# Railyards Specific Plan Update, KP Medical Center, MLS Stadium, & Stormwater Outfall

Final Subsequent Environmental Impact Report

P15-040 | SCH No. 2006032058

October 2016

**Figure 2-42**  
Stadium Grading Plan

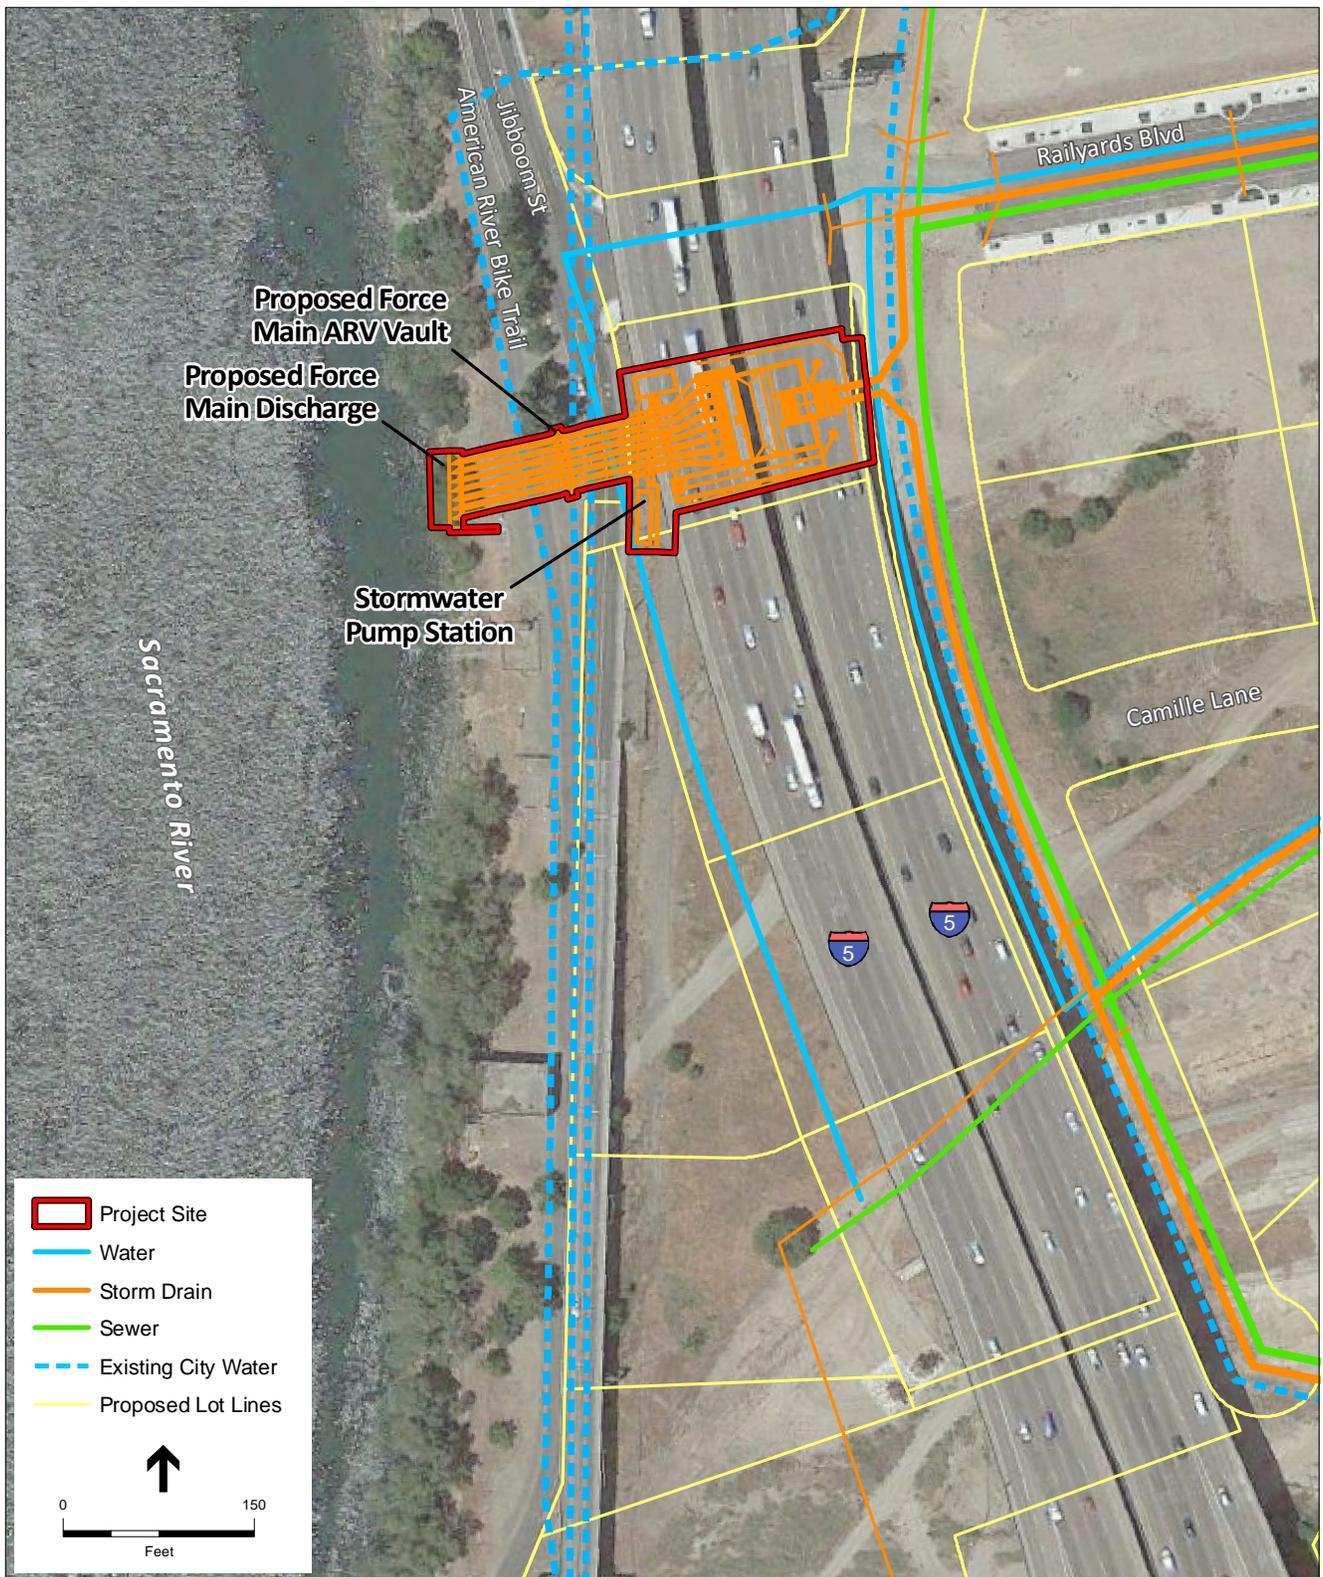
Figure 2-42, Stadium Grading Plan, is revised to show the revised MLS Stadium location moved approximately 40 feet to the north.

**Figure 4.1-21**  
MLS Stadium Articulation

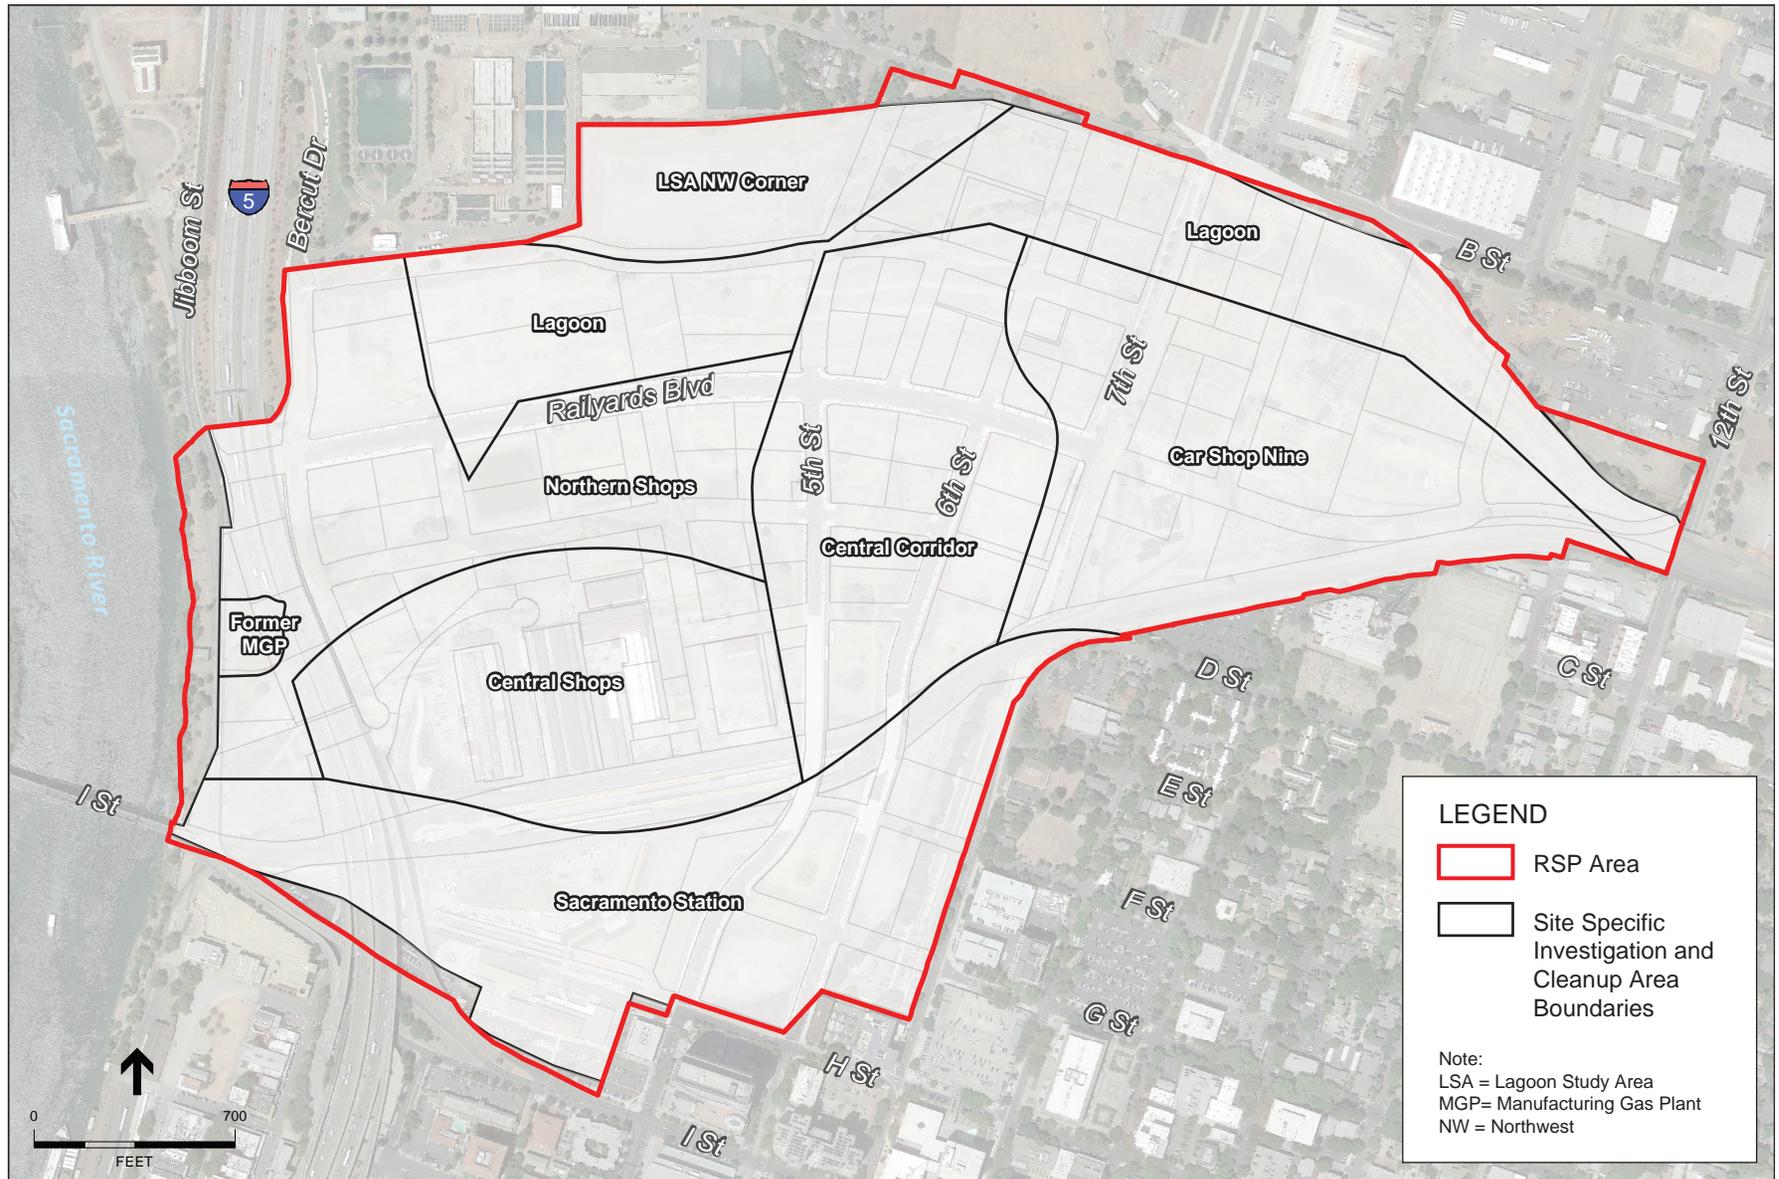
Figure 4.1-21, MLS Stadium Articulation, is revised to show the revised stadium skin.

Sacramento Railyards Specific Plan Update . 150286  
**Figure 4.8-1**  
 Railyards Soil Investigation and Cleanup Areas

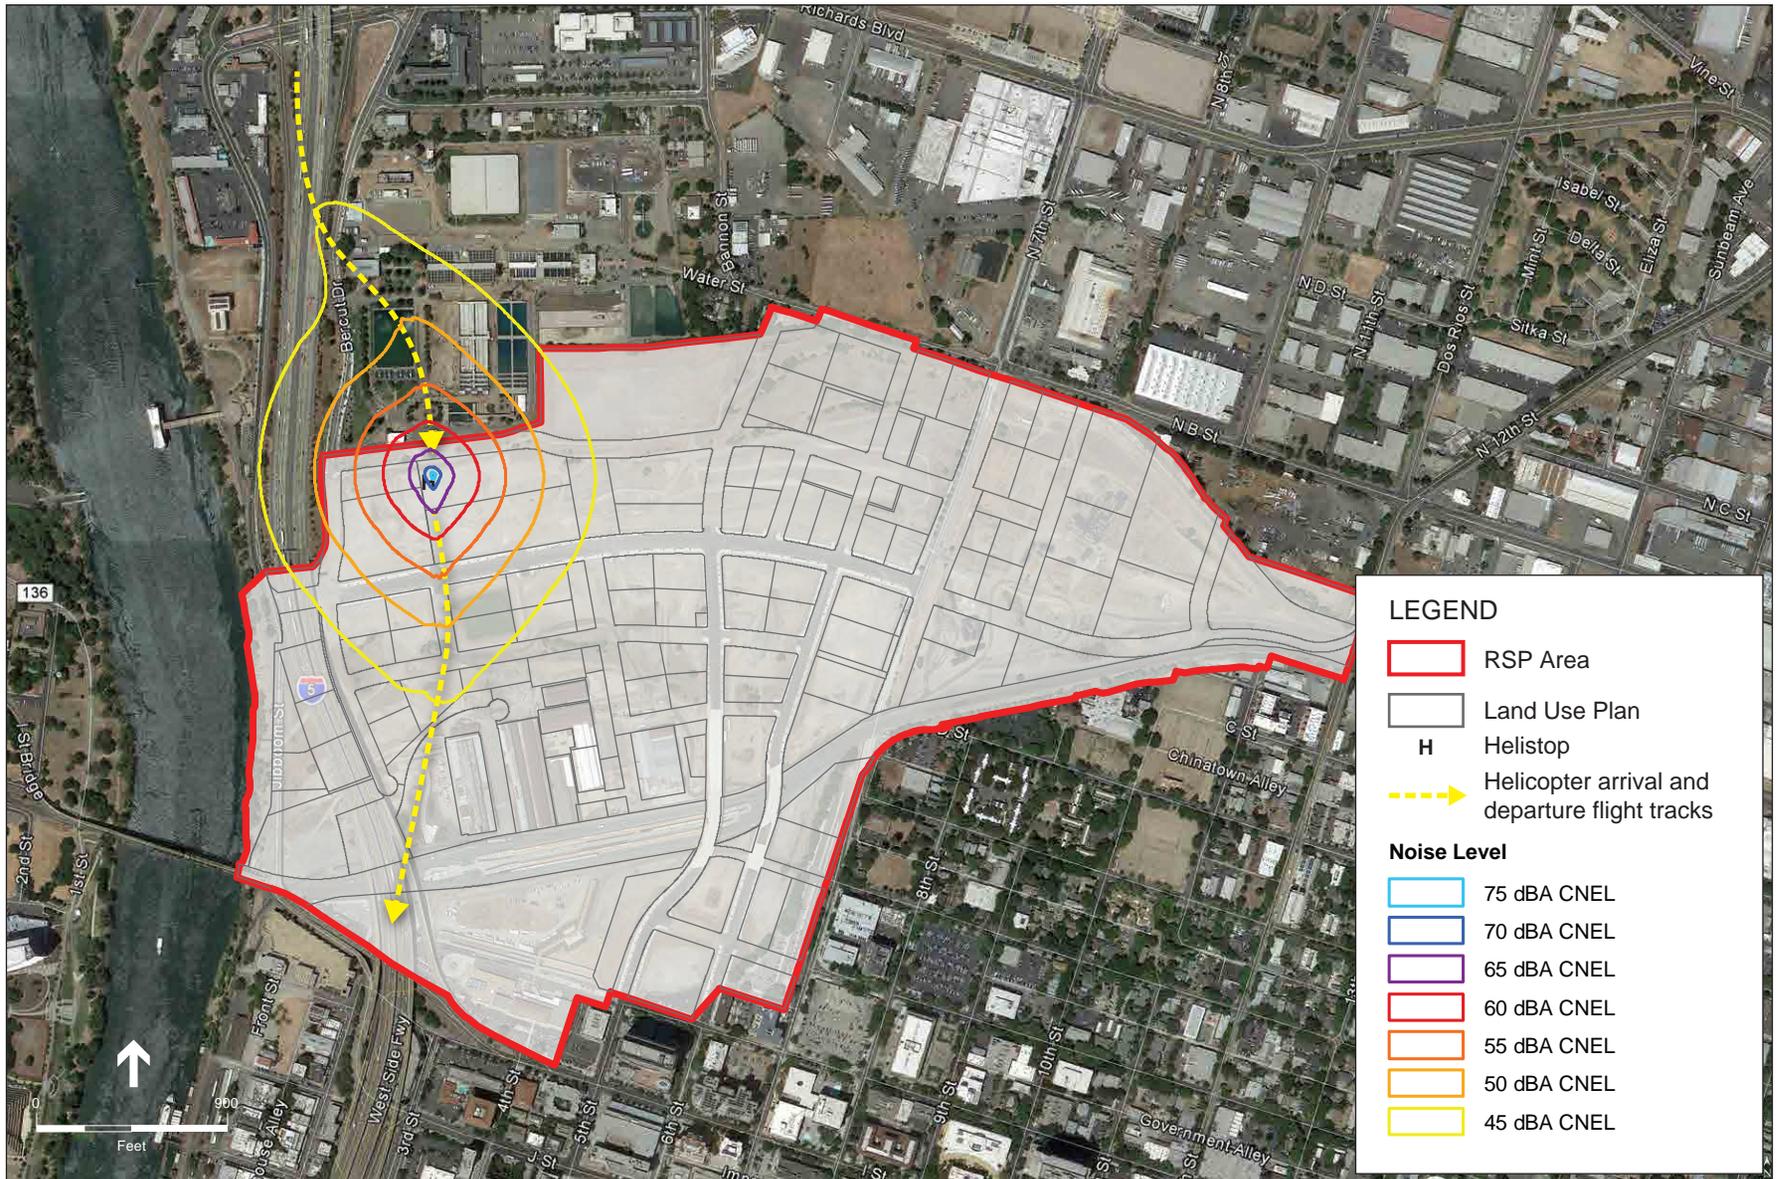
**Comment 1:** Figure 4.8.1 is titled *Railyards Soil Investigation and Cleanup Areas and Planning District Boundaries*. A dashed line is included to outline some areas but the intent of this line is not indicated on the legend. UPRR notes that the areas outlined with dashed lines do not align with the boundaries established for the Study Areas as regulated by DTSC. This figure also includes locations for railroad tracks that are not current.

Figure 4.8-1, Railyards Soil Investigation and Cleanup Areas and Planning District Boundaries is renamed to Railyards Soil Investigation and Cleanup Areas. Additionally, the figure is revised to remove reference to districts within the RSP Area, clarify the boundaries of the Site Specific Investigation and Cleanup Areas, and update the source of the information to a more recent document.

- O2-1      Figure 4.8-1 on page 4.8-5 of the Draft SEIR is revised as requested in the comment and is included at the end of Chapter 2, Revisions to the Draft SEIR.

**Figure 4.10-2**  
 KP Medical Center  
 Helistop 65 dBA CNEL Contour At Ground Level

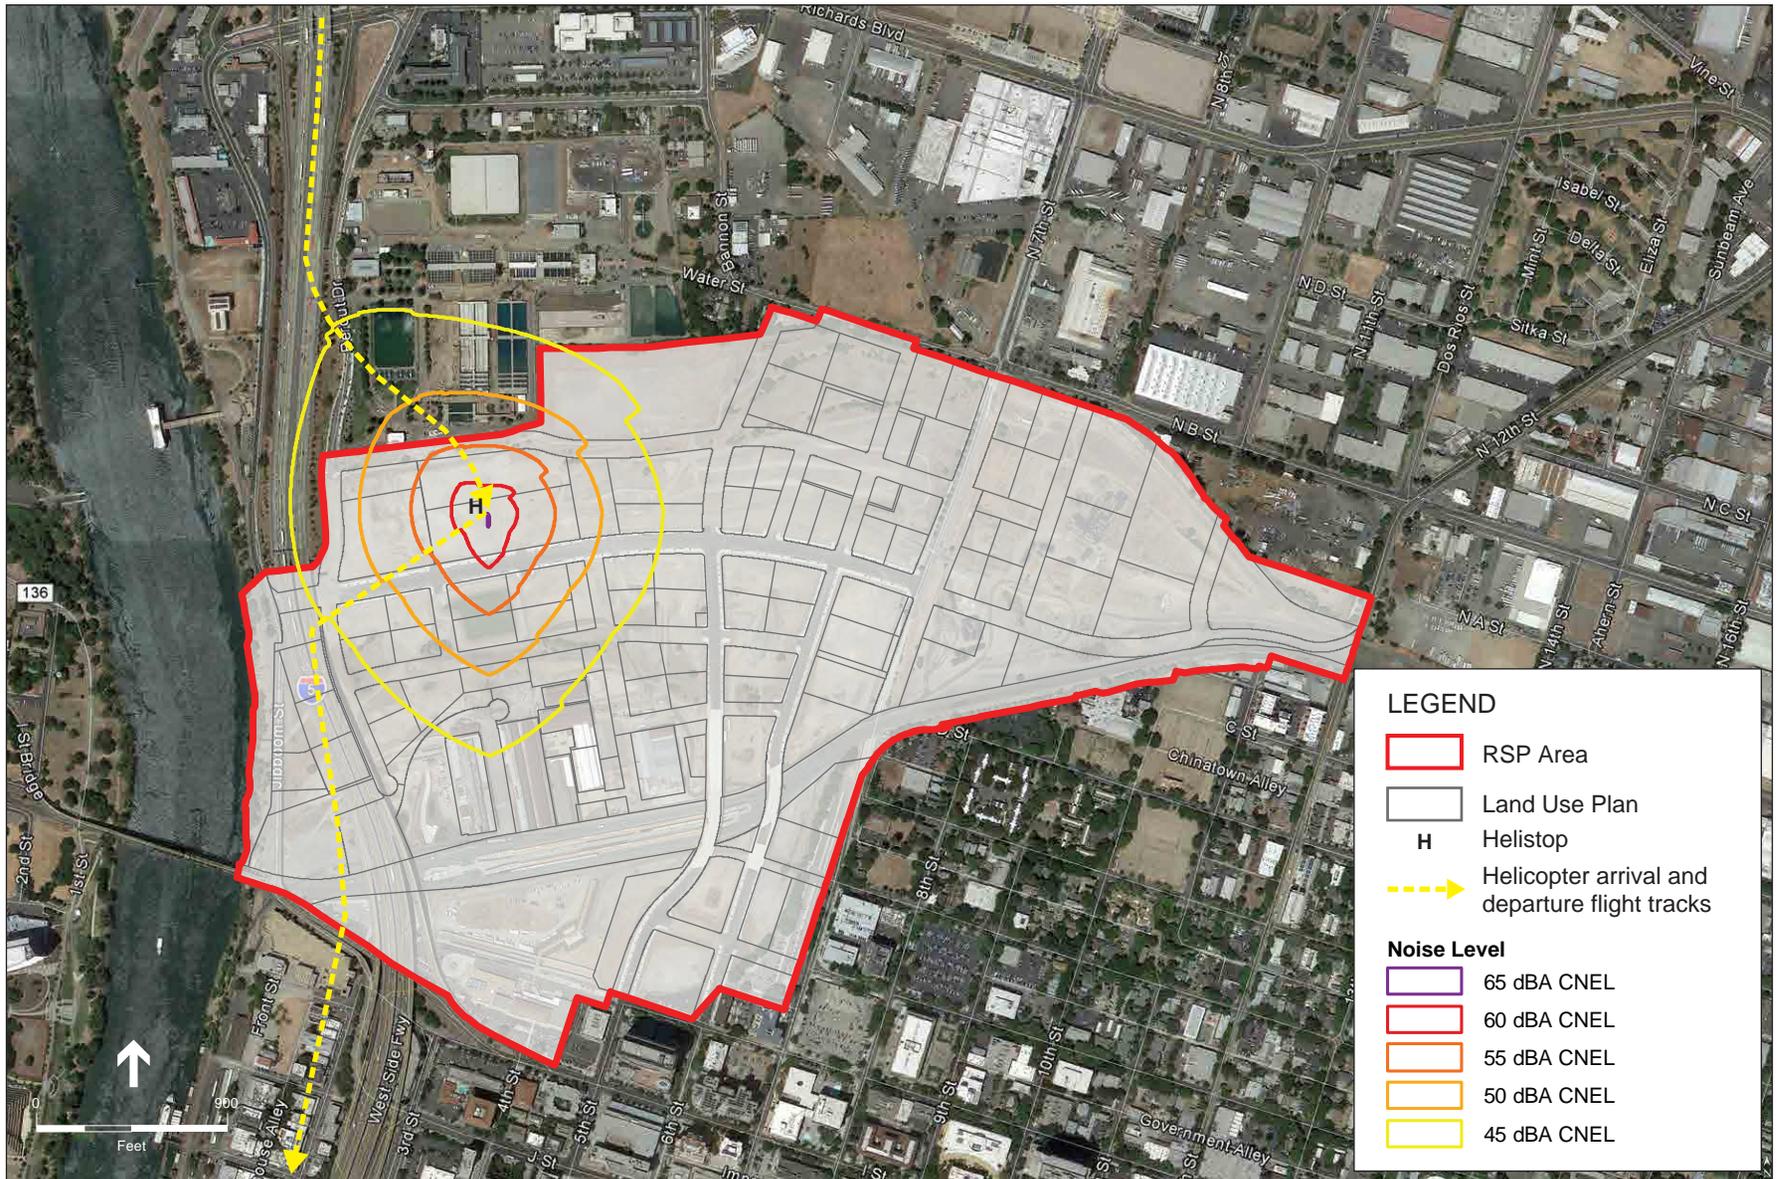
Figure 4.10-2, KP Medical Center Helistop 65 dBA CNEL Contour at Ground Level, is renamed to reflect that the noise is measured in dBA CNEL.
